SRL EAST EES – GLEN WAVERLEY STATION

IAC Hearing – Urban Design Evidence

Craig Czarny

ON BEHALF OF THE CITY OF MONASH (Submitter 260)

UDS: Pg 82 Glen Waverley Fig 18 (cropped)

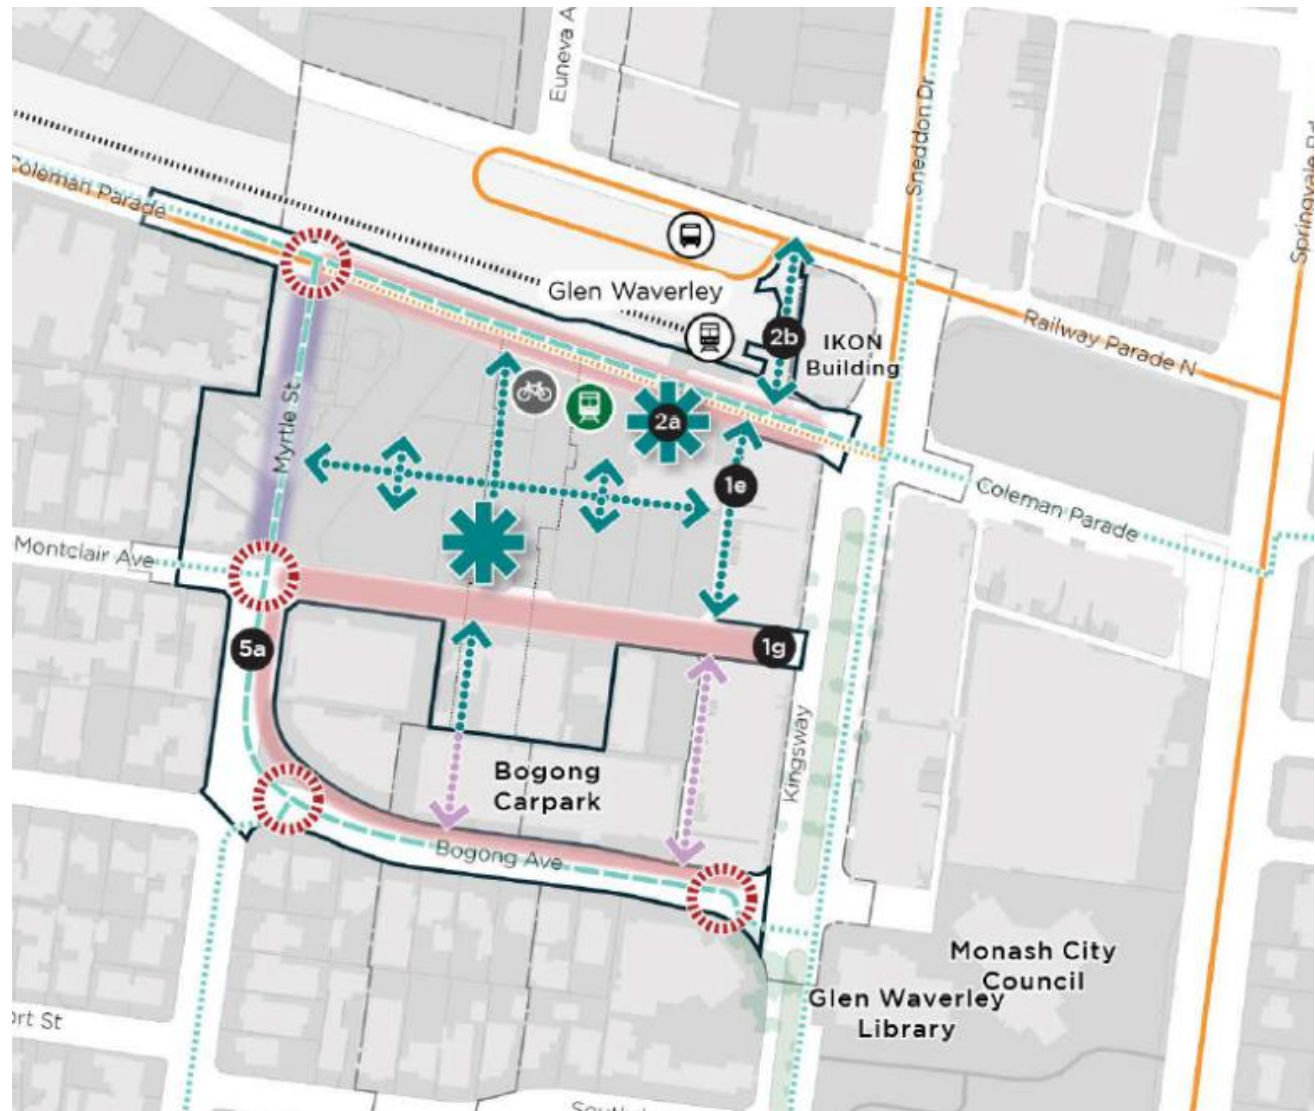
'I believe that Place-specific requirements (and in particular representative diagrams for SRL Station and context) should be strengthened to enable a better understanding of 3-dimensional relationships between Stations, public spaces, future abutting redevelopment and necessary interfaces with land outside the proposed Project'.

Glen Waverley Today: Source Vic Track

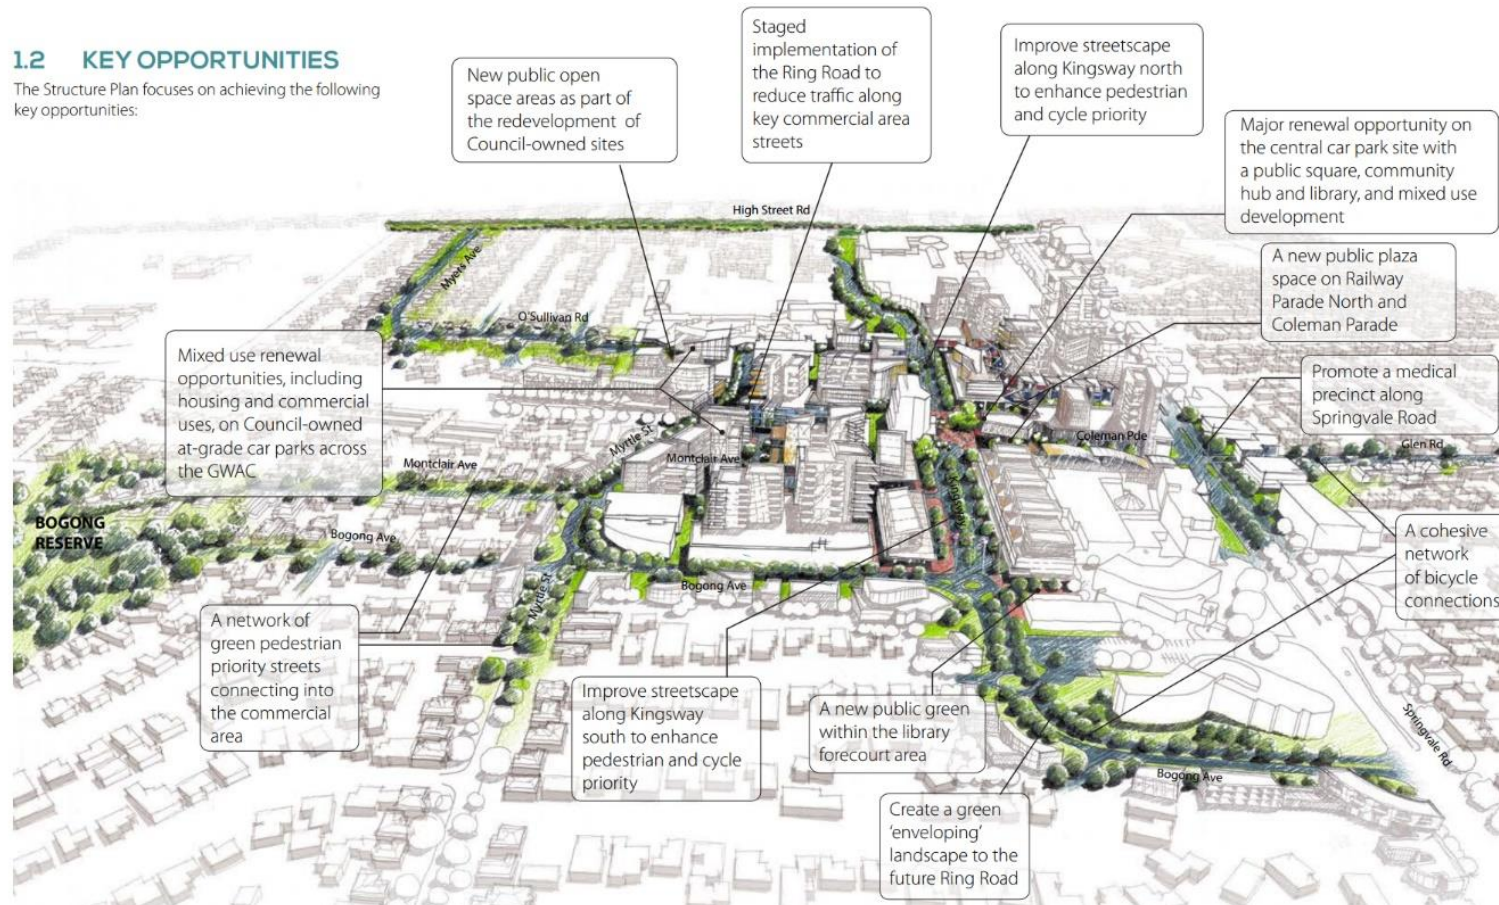
'The positioning of the proposed SRL Station south and west of the existing terminus, physically (and visually) separated from the bus interchange (by at-grade rail infrastructure) and the nearby civic and retail focus is a strategic gesture that has the capacity to distort the MAC's activity focus away from Kingsway, Springvale and High Street Roads'.

Surface Plans for SRL Station at Glen Waverley – Figure DSC9.2 in the Project Description Chapter of the ESS

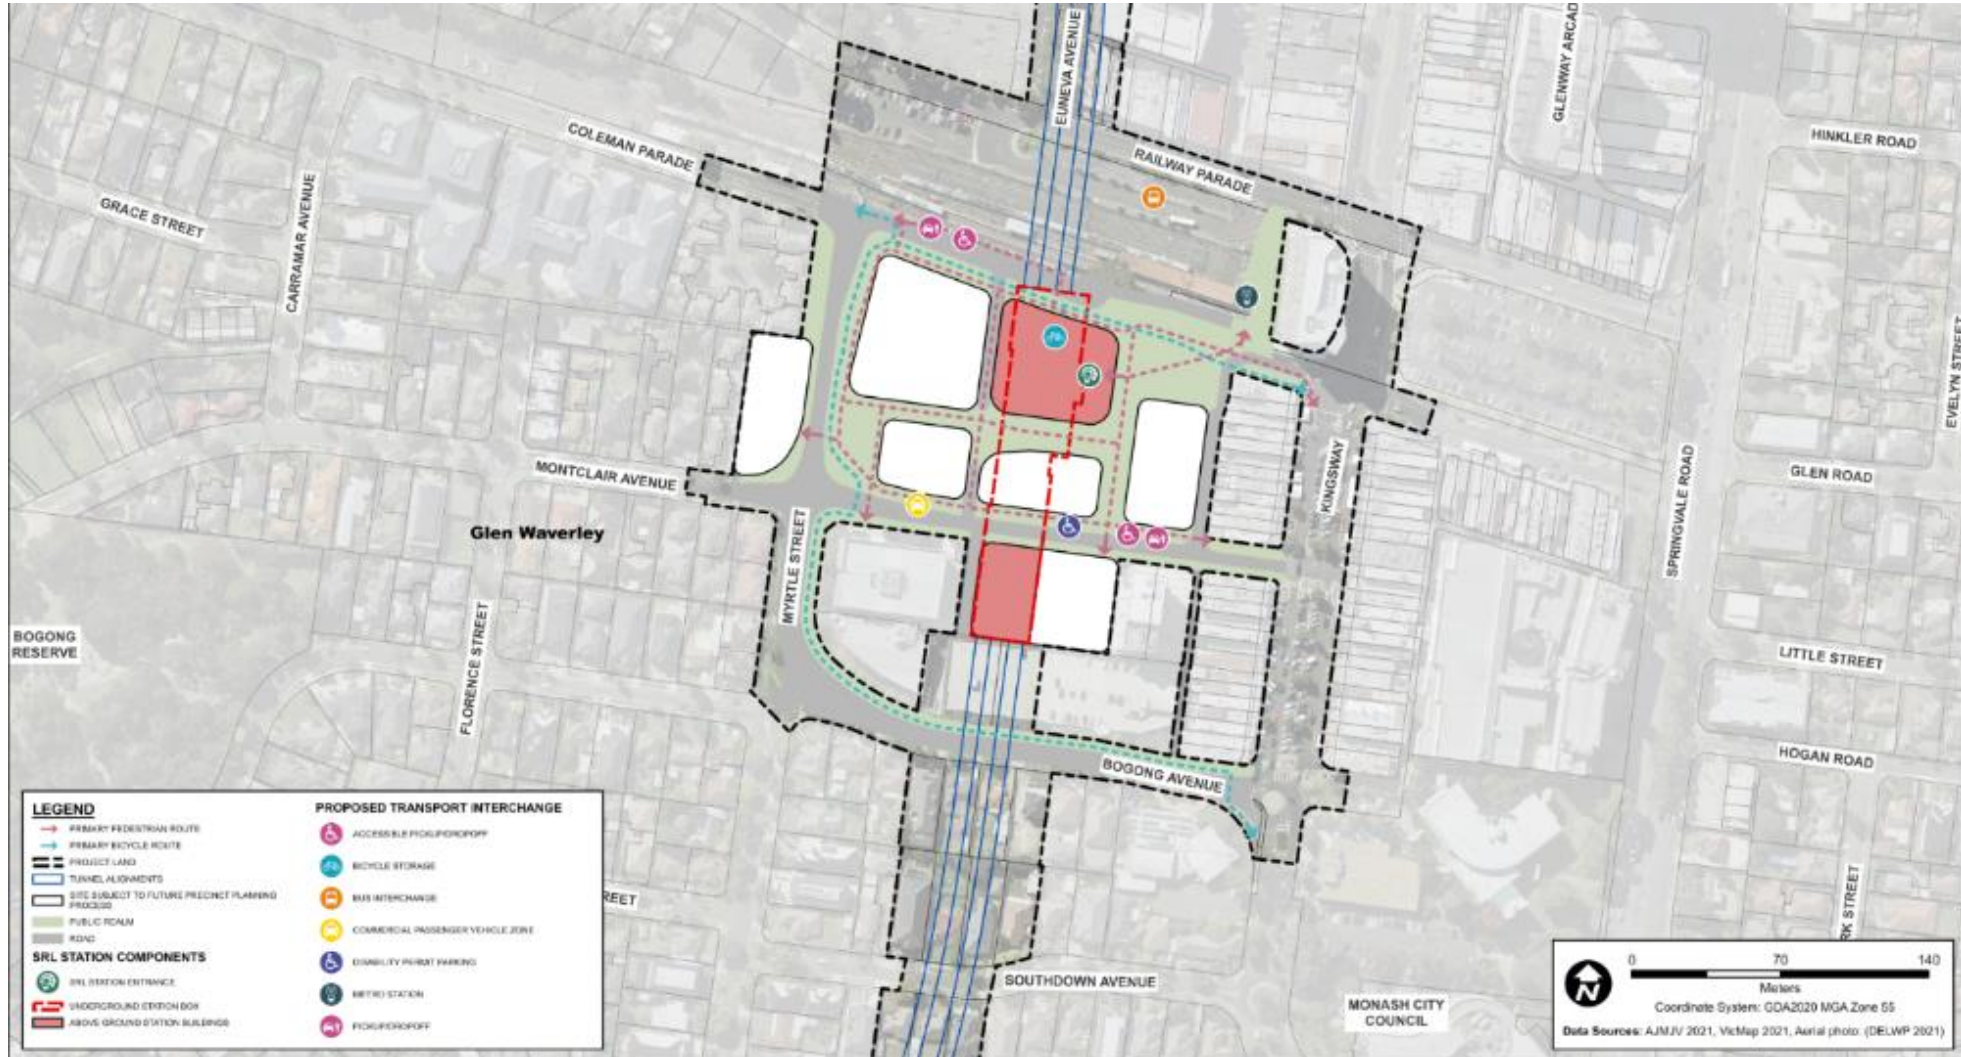
'Orderly Activity Centre planning would in my opinion enable a clearer appreciation of the proposed urban form with respect to skyline, streetscapes, public open spaces and overshadowing.'

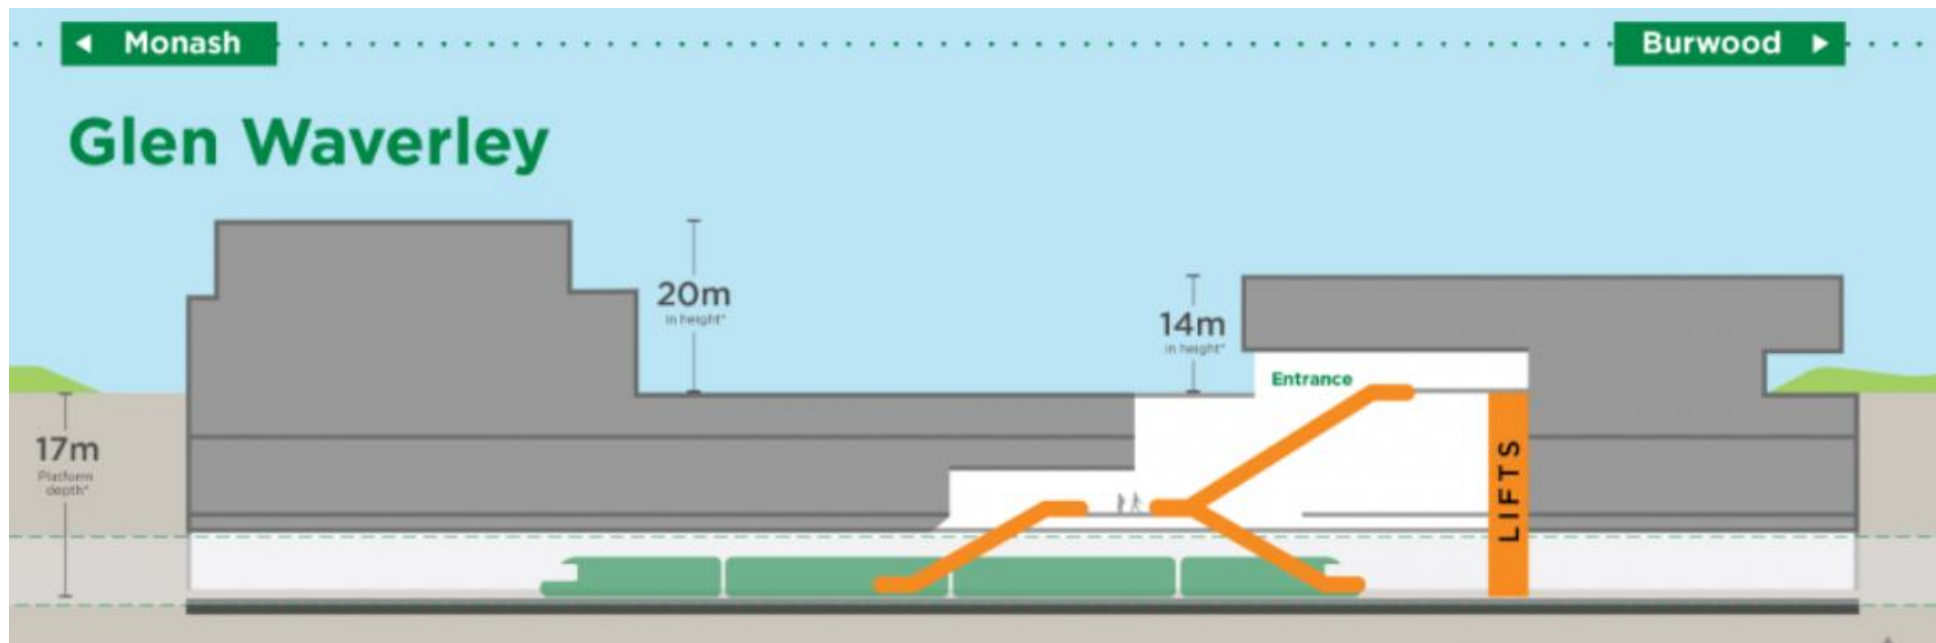
'An open and at grade pedestrian link between the northern portal of the SRL Station, the Glen Waverley Station entry (> 110m away) and bus terminal to the north (> 200m away) does not represent what I consider to be a genuinely integrated approach based on contemporary standards'.
